**ADDENDUM # 1**

RE: **Revised Pavement Schedule**  
Contract ID: DN00629  
County: Cherokee  
Letting Date: April 24, 2018

## TYPICAL SECTION NO. 1

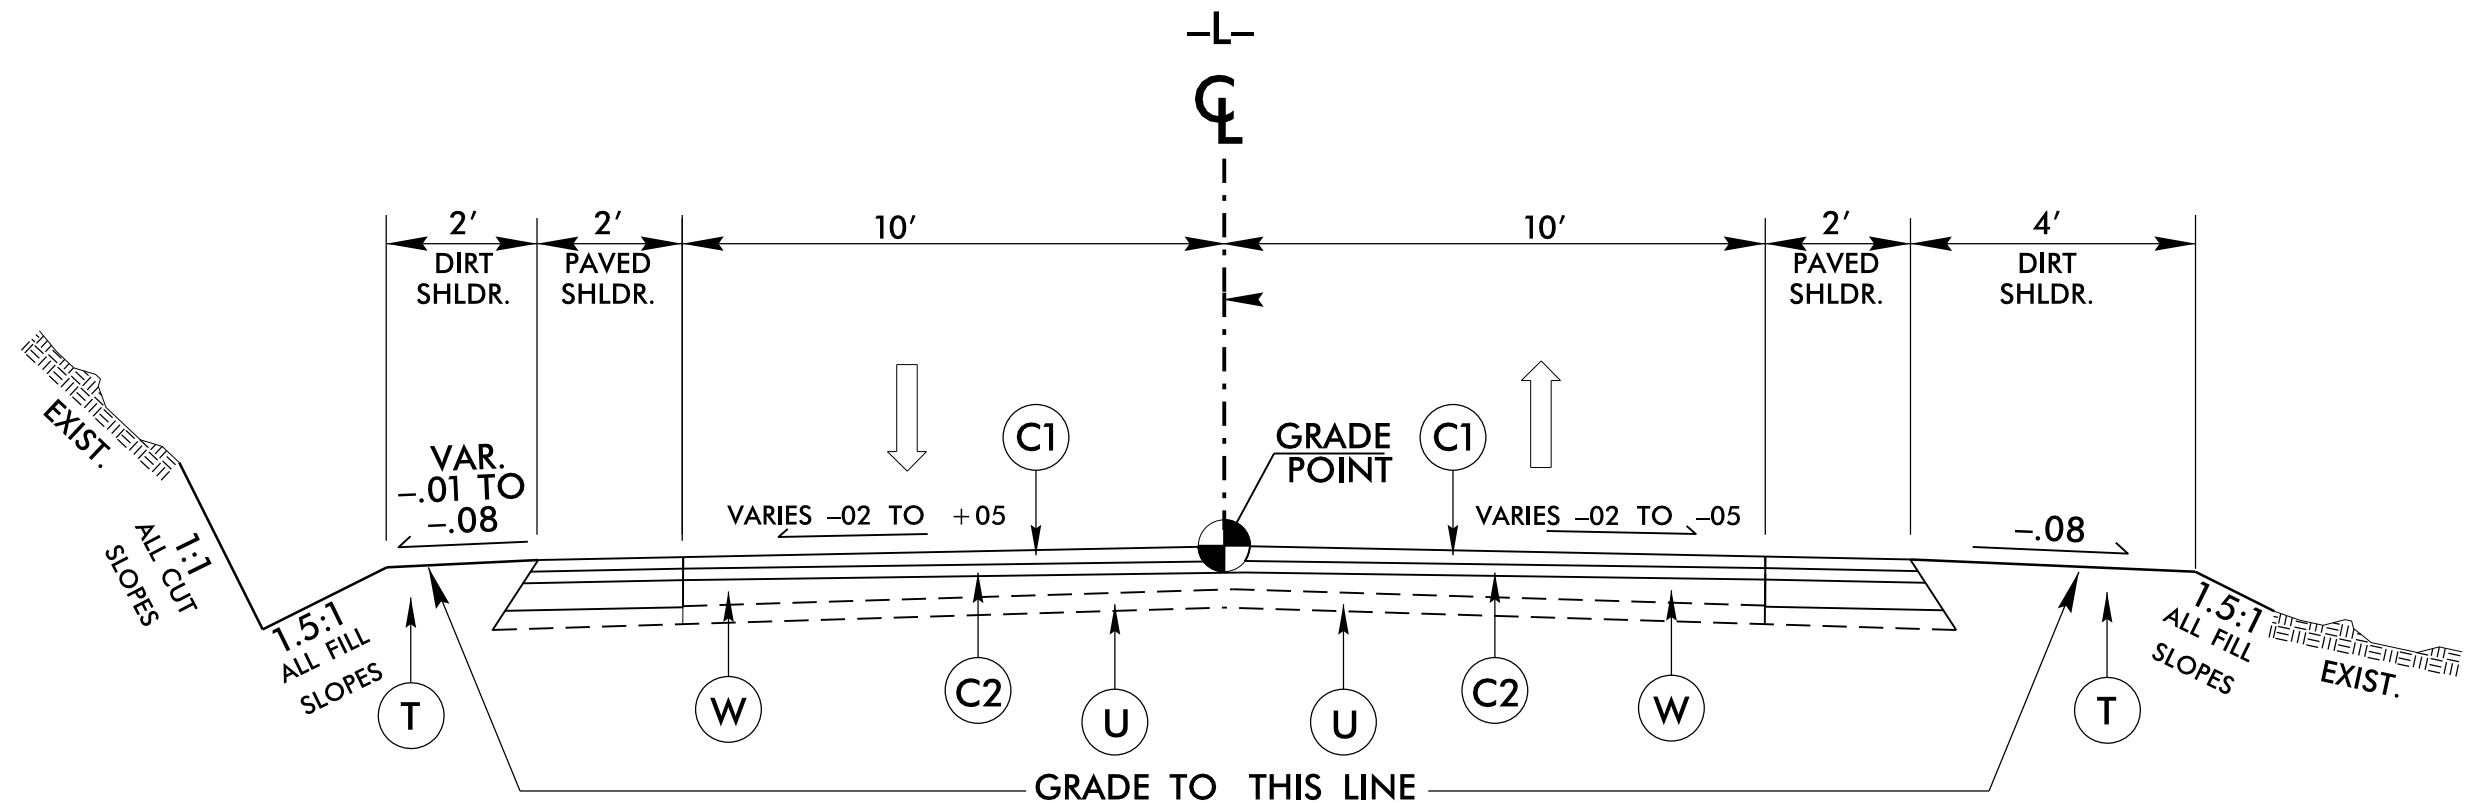
**The Pavement Schedule on the Typical Section Plan Sheet has been revised to reflect the correct mixes as indicated in the Pay Item Sheet in the proposal.**

PAVEMENT SCHEDULE	
C1	PROP. 1.5" DEPTH ASPHALT CONCRETE SURFACE COURSE, TYPE S9.5C AT AN AVERAGE RATE OF 112 LBS. PER SQ. YD. PER 1" DEPTH. TO BE PLACED IN LAYERS NOT TO EXCEED 1½" IN DEPTH.
C2	PROP. 3" DEPTH ASPHALT CONCRETE INTERMEDIATE COURSE, TYPE I19.0C AT AN AVERAGE RATE OF 114 LBS. PER SQ. YD. PER 1" DEPTH. TO BE PLACED IN LAYERS NOT TO EXCEED 3" IN DEPTH.
W	PROP. WEDGING, TYPE I19.0C AT AN AVERAGE RATE OF 114 LBS. PER SQ. YD. PER 1" DEPTH. TO BE PLACED IN LAYERS NOT TO EXCEED 3" IN DEPTH.
T	EARTH MATERIAL
U	EXISTING ASPHALT ROADWAY
